Staff Report

Date: April 26, 2021
To: **Devens Enterprise Commission**
From: Peter Lowitt, Director and Neil Angus, Environmental Planner
RE: **16 Bulge Level 2 Unified Permit Amendment Request**

Owner/App.: Scannell Properties #460.
Location: 16 Bulge Road, Devens, MA
Zoning: Innovation & Technology Business District (ITB), Watershed and Aquifer Water Resources Protection Overlay Districts and Slope Resource Area.

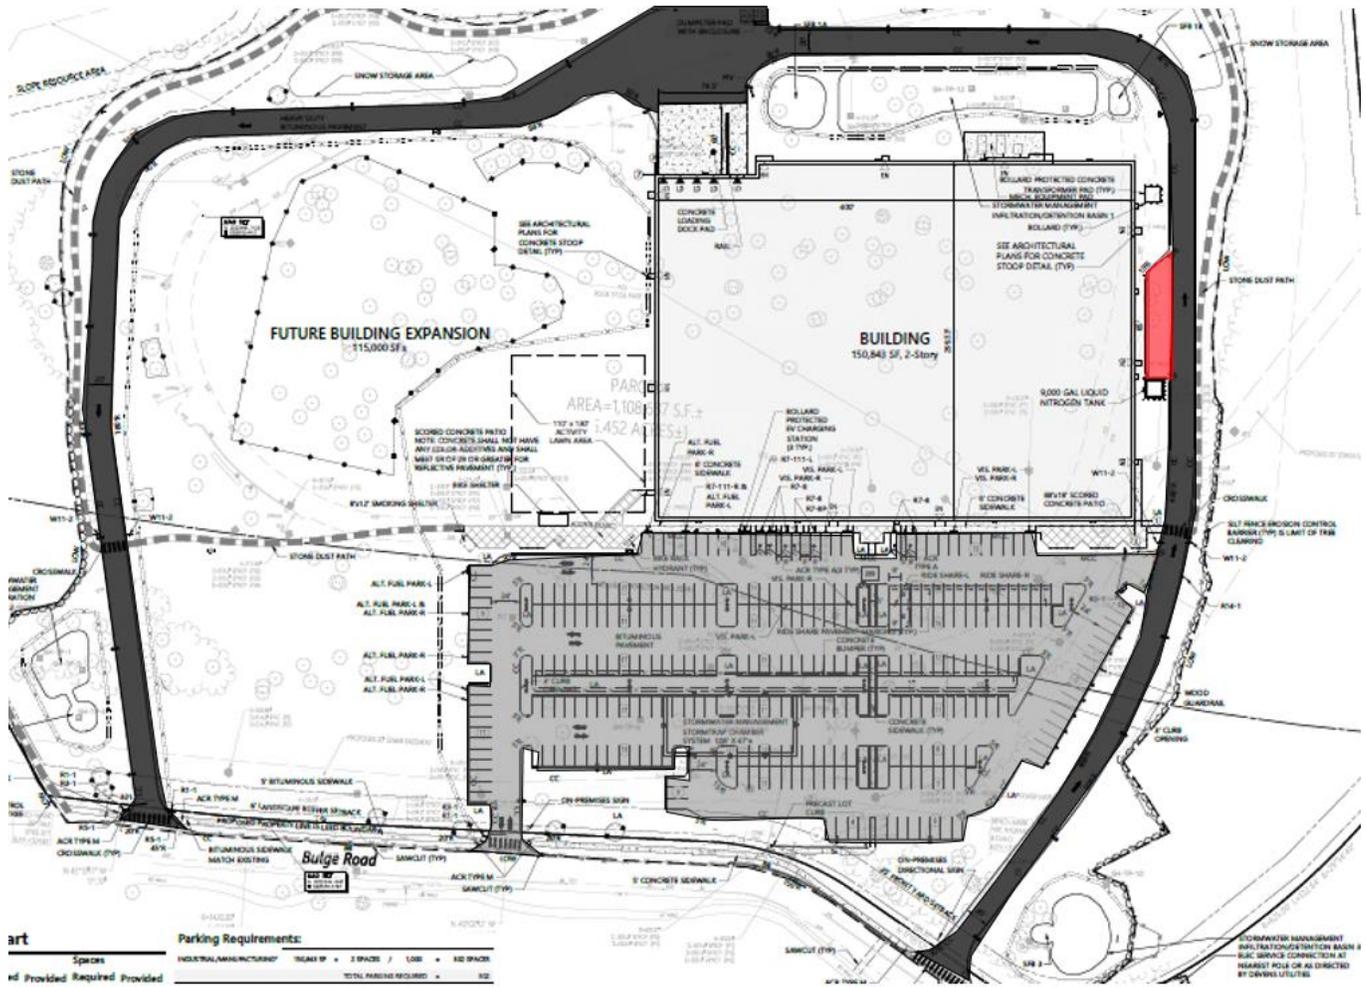
The areas of light duty pavement apply to the parking lot in front of the building (gray shaded areas) and the heavy duty pavement areas apply to the main entrance drive and perimeter road around the building where larger trucks will be accessing the property (black shaded areas):

The red shaded area is a liquid nitrogen tank loading area that will be subject to truck traffic as well so the Applicant should ensure this area is either reinforced cement concrete or heavy duty pavement.

1. The "Compacted subgrade" portion of each pavement detail shall be updated to include "Compacted subgrade, free of frost, roots, and debris".
2. The liquid nitrogen tank loading area shall be modified to reinforced cement concrete or heavy duty pavement.
3. The Applicant shall provide the DEC gravel sieve analyses, compaction tests, pavement slips, and copies of any third-party inspection reports for all site paving. The DEC peer review consultant will review this information to confirm compliance with the approved pavement modification. The Applicant shall pay for all consultant costs associated with construction inspections and monitoring.
